Comments from Öko-Institut on the ENTSOs TYNDP 2020 Draft Scenarios

Freiburg, 15.01.20

On 12 November, ENTSO-E and ENTSG published their joint draft [scenarios](#) of the TYNDP 2020 and made them available for public consultation. Based on the feedback, the scenarios will be finalised by March 2020. The scenario set consists of the three scenarios National Trends, Distributed Energy and Global Ambition. National Trends is based on the current goals and plans of individual European countries. The Distributed Energy and Global Ambition scenarios were developed with the aim of meeting the Paris climate targets. Distributed energy is a scenario with a more decentralized approach and global ambition with a more centralized approach.

Figure 1-1: GHG emissions compared to 1990 level

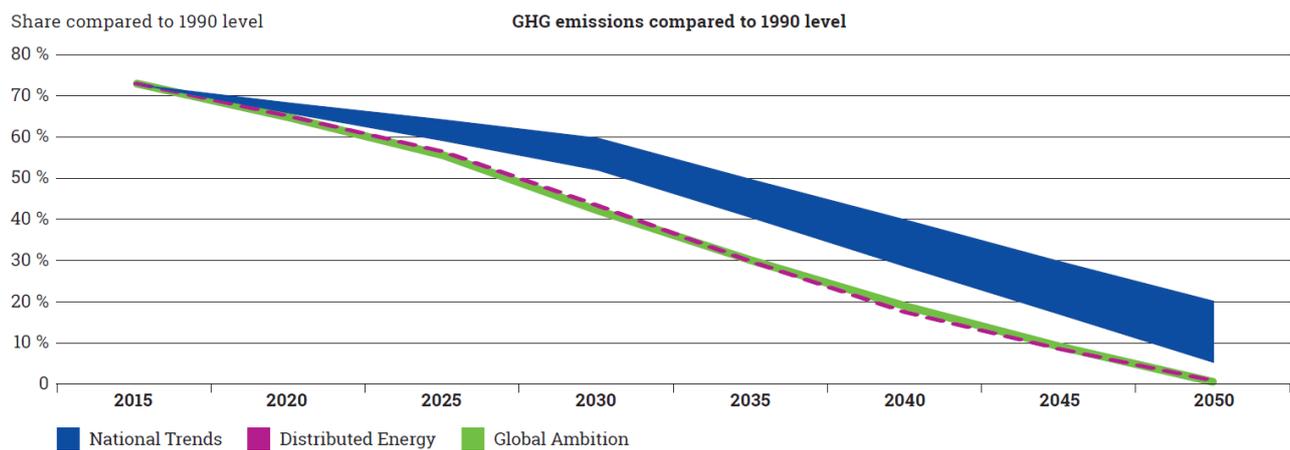
- It is not clear how the yearly emission targets were set.
- A faster emission reduction would diminish the dependency on CCS and the associated uncertainty regarding feasibility and costs.

The two ambitious scenarios show, with a linear reduction between 2025 and 2050, the same development in emission reductions (see Figure 1-1). A comparison of emissions in the electricity sector shows that in 2030 even all three scenarios are at the same level. In order to maintain an ambitious GHG budget, it is essential to reduce emissions at an early stage. As these early efforts can also unfold their effect in all subsequent years. Since this is not implemented in the TYNDP scenarios, the set overall budget is exceeded before 2035. All subsequent emissions must be later removed from the atmosphere. For this reason, after achieving climate neutrality in 2050, approximately 15 Gt will have to be offset by negative emissions until the year 2100. The decision for a linear emission reduction and the resulting need to withdraw emissions from the atmosphere is seen critically for the following reasons:

- Carbon Capture and Storage or Usage (CCS/CCU) technologies are not yet tested on a large scale. There are also unanswered questions regarding their implementation costs or the acceptance of final disposal.
- These uncertainties lead to a shift of responsibility and costs from the generation that draws up these plans to following generations.
- It doesn't reveal itself why the emission reduction was defined as a linear path. This approach puts the Paris-compatibility of the scenarios at risk, as it is unclear whether the required carbon capture technologies will be available.
- At least one scenario should consider a faster emission reduction to reduce the dependency on CCS.

Figure 2-1: Installed wind and solar capacities for EU28

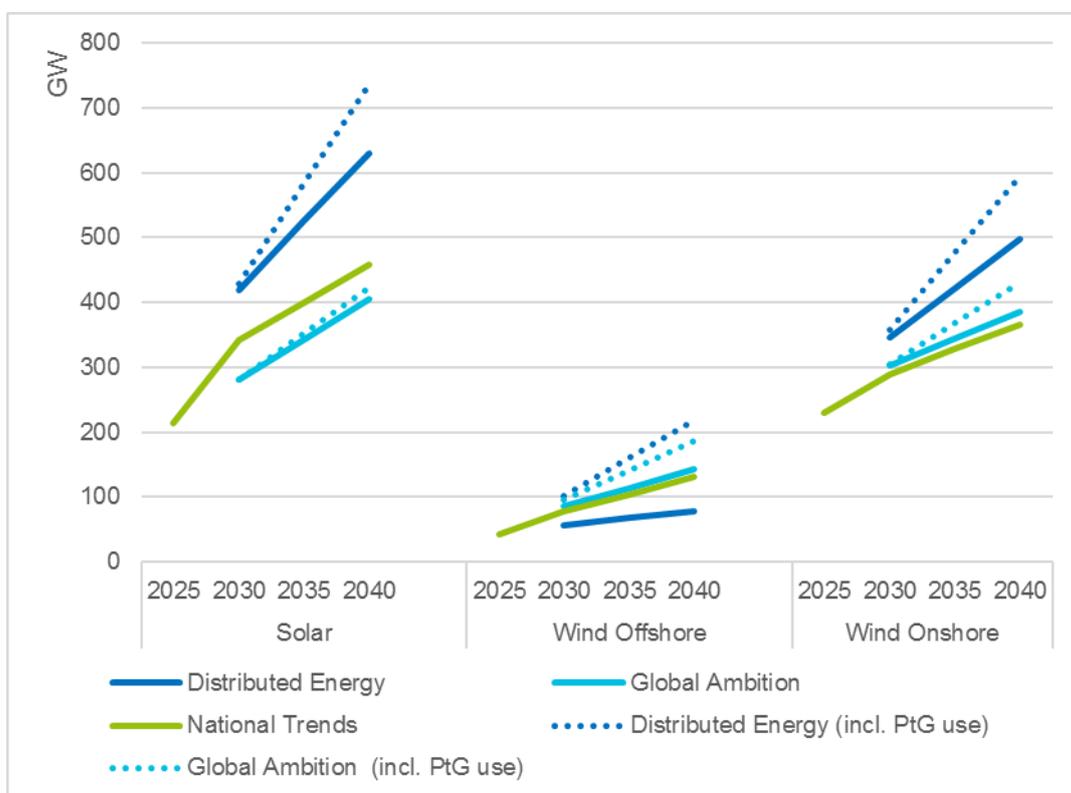
In Figure 2-1 the installed wind and solar capacities for EU28 are shown. It should be noted that in the Paris scenarios, wind and solar systems are foreseen, whose electricity is used exclusively for Power-to-Gas (PtG) applications (dotted lines). This is approach is discussed in chapter 4.

The installed grid-connected solar capacities are much lower than in the TYNDP 2018 (-110 GW Distributed Generation and -180 GW Global Climate Ambition). If the plants used for PtG production are also included the Distributed Scenarios reach roughly the same level. It would have been expected that the additional efforts to achieve a 1.5° scenario would result in additional solar capacity and not in an equal level or even capacity reduction.

Figure 2-2: Projected Electricity Demand and Wind/Solar Generation for EU28

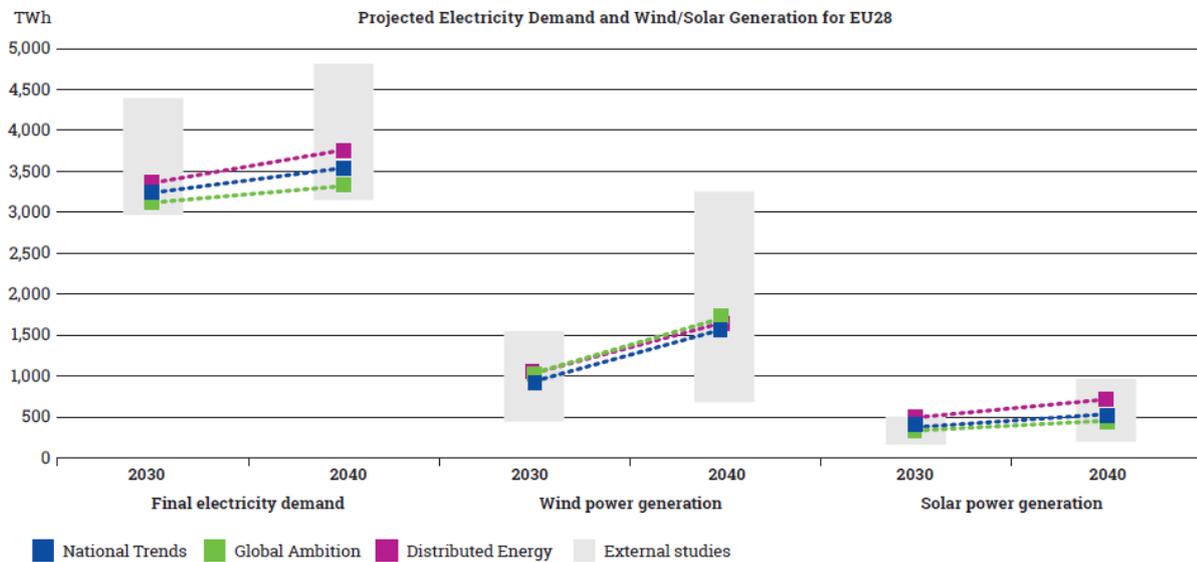
Compared to the last TYNDP, the wind capacities increase significantly, but in comparison to other scenarios the wind generation for the year 2040 is in the lower third (see Figure 2-2). The grid-connected wind capacities of the Global Ambition scenario are roughly at the level of national trends; a significant increase in capacity would have been expected for a 1.5° scenario. In line with the storyline, the grid-connected offshore capacities of the Distributed Energy Scenario are signifi-

cantly lower. But if the plants for PtG use are considered, the offshore capacities are almost three times higher and even exceed the capacities of the Global Ambition scenario.

- the electricity demand is relatively low compared to other studies (it is only in the lower half of the scenario range as can be seen in Figure 2-2 as well as for the amount of heat pumps as an indicator for the electrification of heat supply which is shown in figure of 11 of (ENTSO-E; ENTSOG 2019, p. 22)) and
- the gas demand is above the 1,5°C scenarios from the EC long term strategies and other ambitious scenarios (ENTSO-E; ENTSOG 2019, p. 42) and
- renewable gases and CCS are the main decarbonisation strategies.

Figure 4-1: Installed Power-to-Gas and dedicated RES-E plants

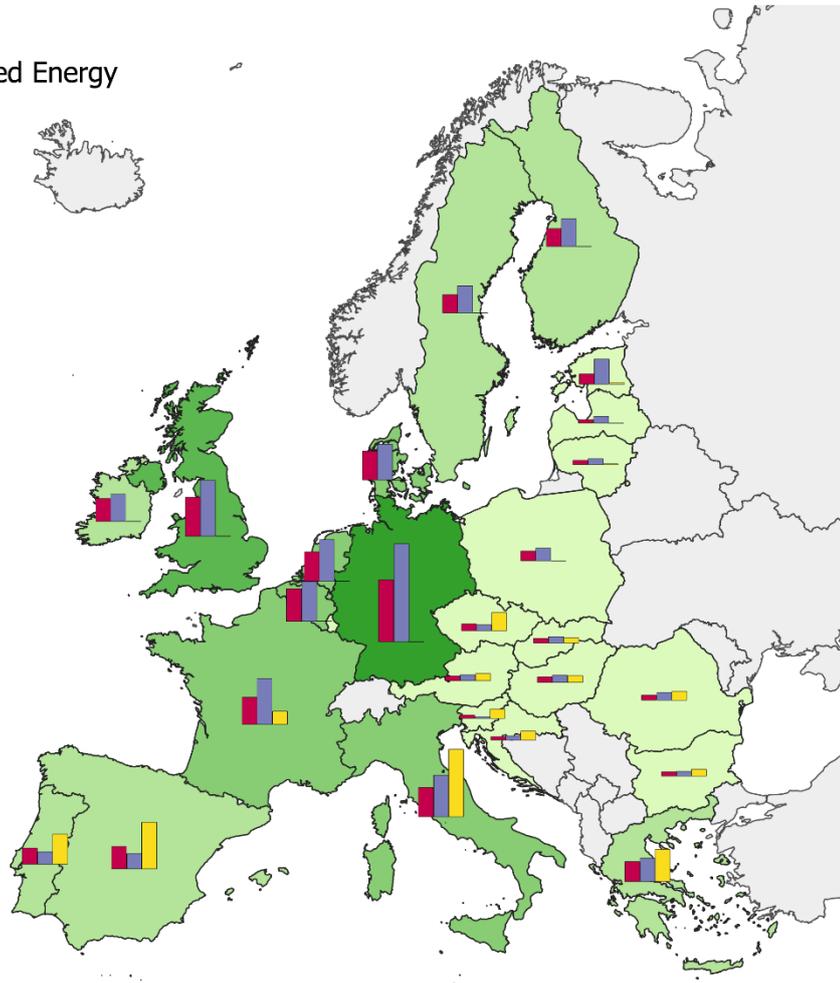
Direct connection to RES-E source is in line with RED II. However, it is questionable if segregating RES-E sources and PtG from the electricity grid is the way to go: This pathway does not use the effect of geographical balancing of variable RES-E feed-in and therefore might increase total amount of RES-E.

We question, why overall capacities for RES-E dedicated to PtG production exceed the capacity for P2G (see Figure 4-1). This assumption increases full load hours for P2G but also increases curtailment of RES-E generation. We question if this model can be economically feasible?
